Serial No. 10/707,567
Filed: December 22, 2003
Page 5 of 10

Amendments to the Drawings:

Objections to the Drawings

Fig. 12

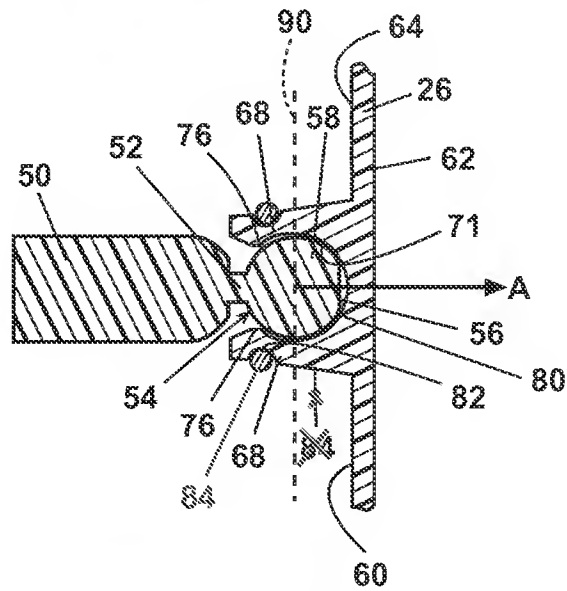
The Examiner asserts that element 84, shown in Figure 12, does not properly point to the compression spring. Figure 12 has been amended so that element 84 points to the compression spring.

Fig. 16

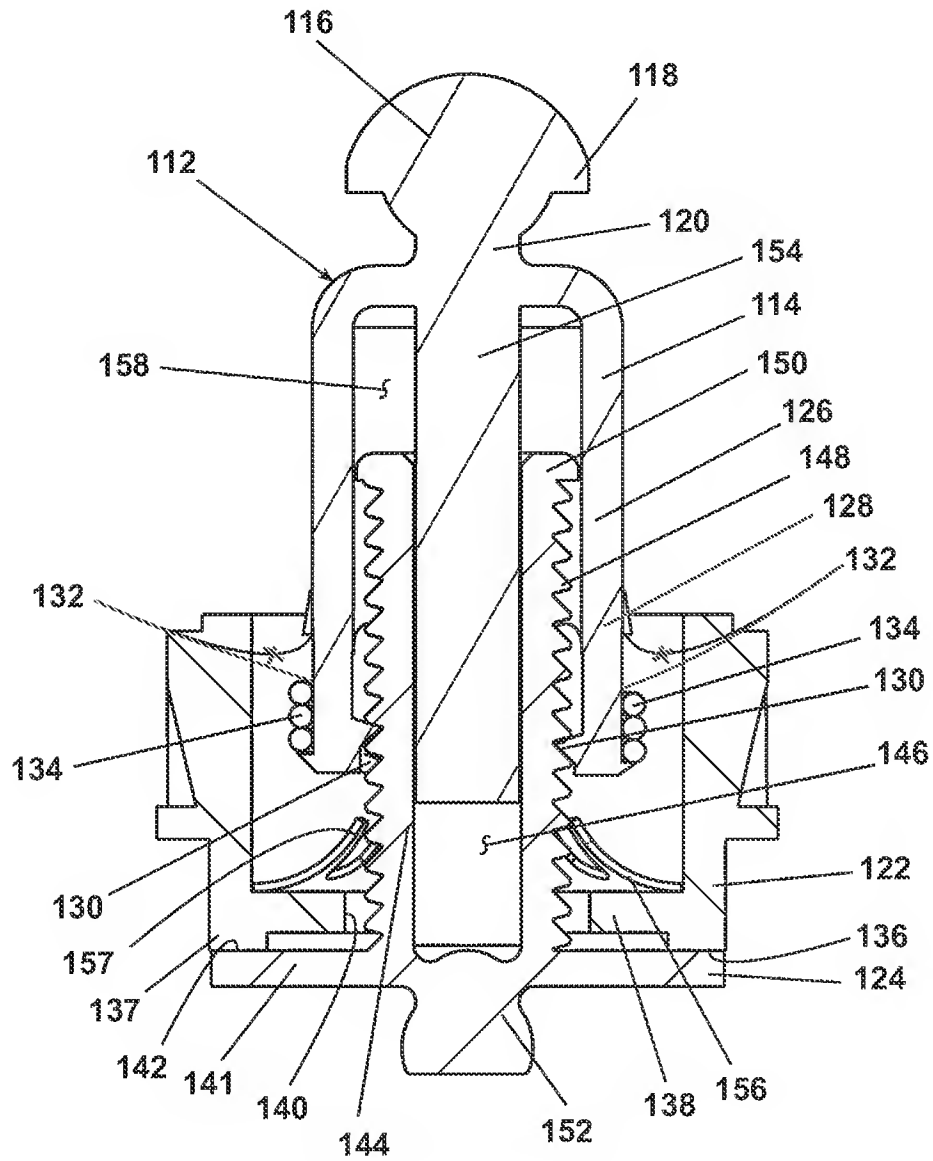
The Examiner asserts that element 128 shown in Figure 16 fails to include a lead line. Figure 16 has been amended to show a lead line from element 128 to the appropriate structural element.

The Examiner asserts that element 132 shown in Figure 16 does not properly point to the spring channel. The lead lines from element 132 have been redrawn in Figure 16 to more clearly point to the spring channel.

Fig. 18

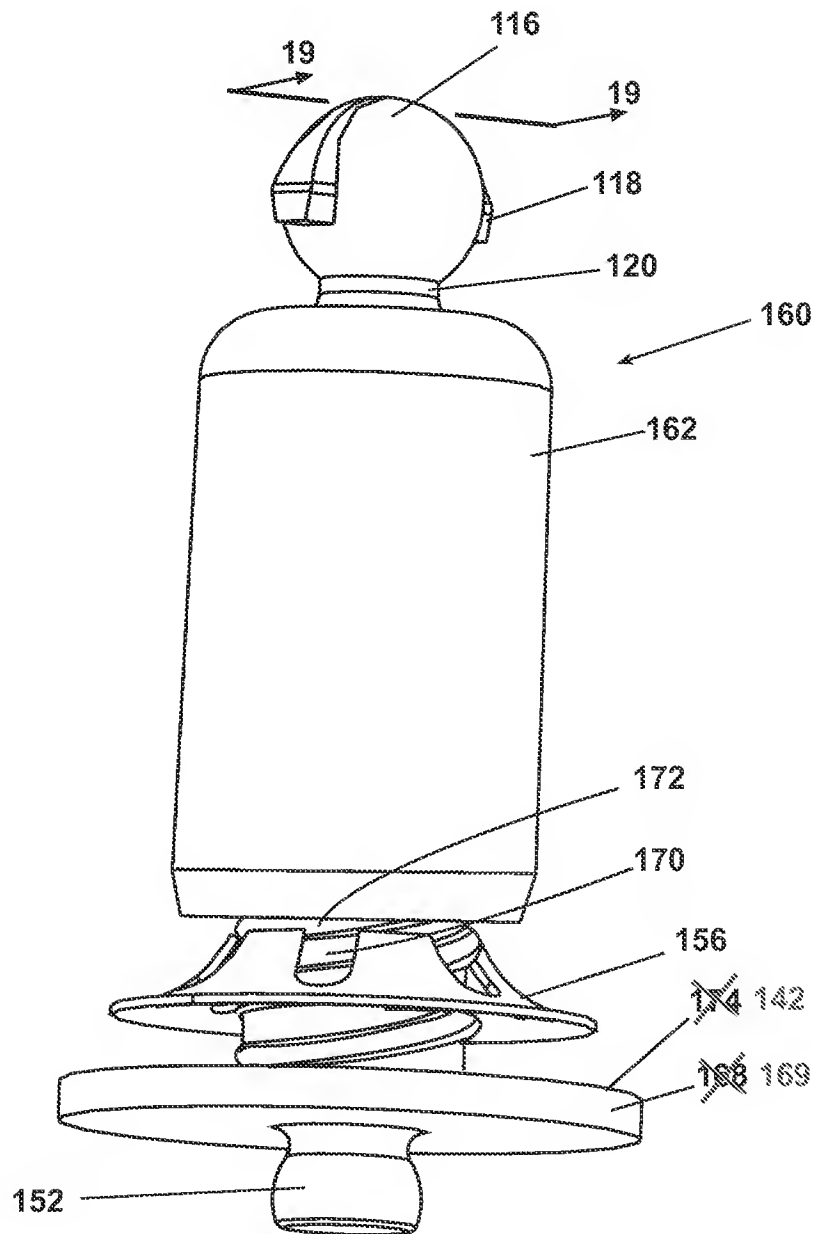
The Examiner asserts that reference numeral 174, shown in Figure 18, lacks a proper written description. Figure 18 has been amended to change reference numeral 174 to reference numeral 142, which has a proper written description. Moreover, reference numeral 168 has been changed to reference numeral 169 to correct a typographic error.
